## ST. MARY'S HOSPITAL

July 6, 1977

BOARD OF DIRECTORS Teletherapy License # 45-11367-01 Control # 86852

In answer to your letter of June 17th we are now answering your questions with regard to the new room for our Cobalt therapy unit. Our answers bear the same numbers as your questions.

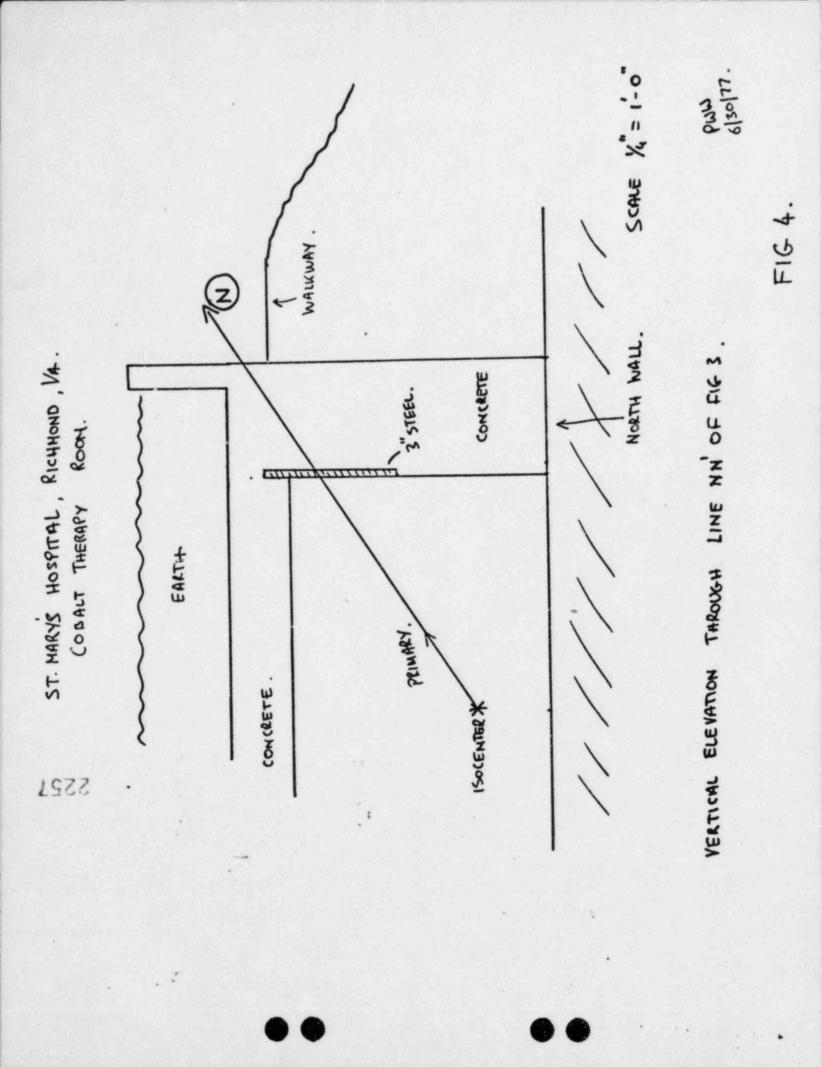
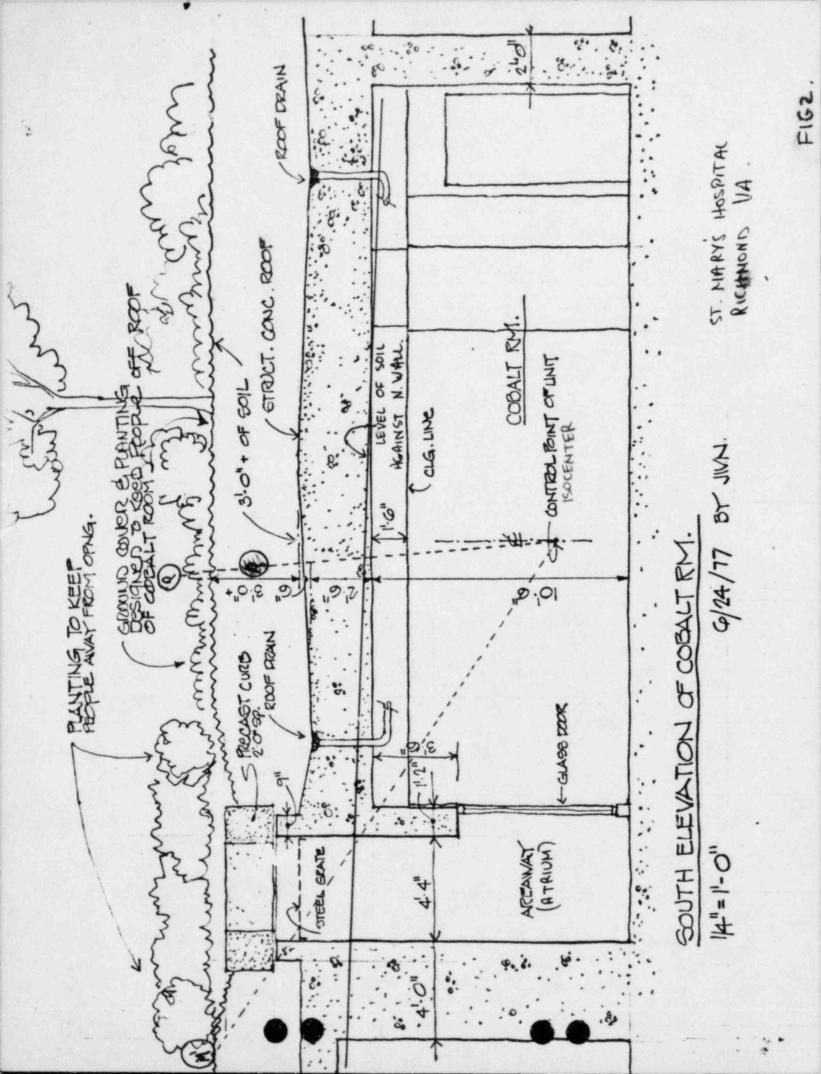
- 1. Patient viewing is by closed circuit television with the camera located as shown on figure 3 (large plan), where its view can never be obscured by the machine. The camera has remote pan and tilt adjustment. In case of TV System failure, treatment will be suspended until it is repaired. "In house" repairman and back-up system are available.

- 3. We have attached improved copies of figures 2, 3, and 4 as requested which have been modified as requested.
  - (a) All concrete used in shielding construction has a density of 147 lb./ft.<sup>3</sup>. The room is submerged below ground level with nothing beneath it.

- (b) The adjacent rooms to the E, W and S are shown on figure 3. The north wall is below ground level with a walkway passing at ceiling level--see figure 3 and soil level on figure 2. Above the roof is a garden area with shrubs to discourage people from frequenting the area.

(c) The atrium (areaway) area is best seen in the plan figure 3 and the South elevation (figure 2 . Access to the atrium is through the treatment room via the glass partition. A steel grating covers the atrium area.

(a) The radiation levels outside the door due to penetration through the primary barrier (location J on figure 3) was Richard D. O'Hallaron F.A.C.H.A. calculated in our original letter to be 0.00044 mr/hr.

The exposure rate due to door ( $\frac{1}{4}$  lead) penetration is due only to double scatter. The exposure, due to patient scatter, striking the wall inside the door beyond the maze wall is estimated to be 450 mr/hr. If this strikes an area of 4' x 8' of wall located 3 meters from the door, and we get 0.1% scatter at 1 meter for each 400 in.<sup>2</sup>, then the exposure rate at the door would be

$\frac{450 \times .001 \times 8 \times 4 \times 144}{400} \times \frac{1}{3^2} = 0.58 \text{ mr/hr}.$

(b) Exposure at location R on figure 3. This room will contain a linear accelerator. The wall is 2 ft. thick (concrete), has an attenuation of 0.0001, and is a secondary barrier receiving exposure scattered at 90 degrees from the patient (scatter factor=0.9x10<sup>-3</sup> at 1 meter). The distance to point R is 7 meters so the exposure rate is

16,700 R/hr. (at 60 cm.) x 0.9 x  $10^{-3}$  x 0.0001 x  $10^3$  x  $\frac{1}{72}$  = 0.03 mr/hr.
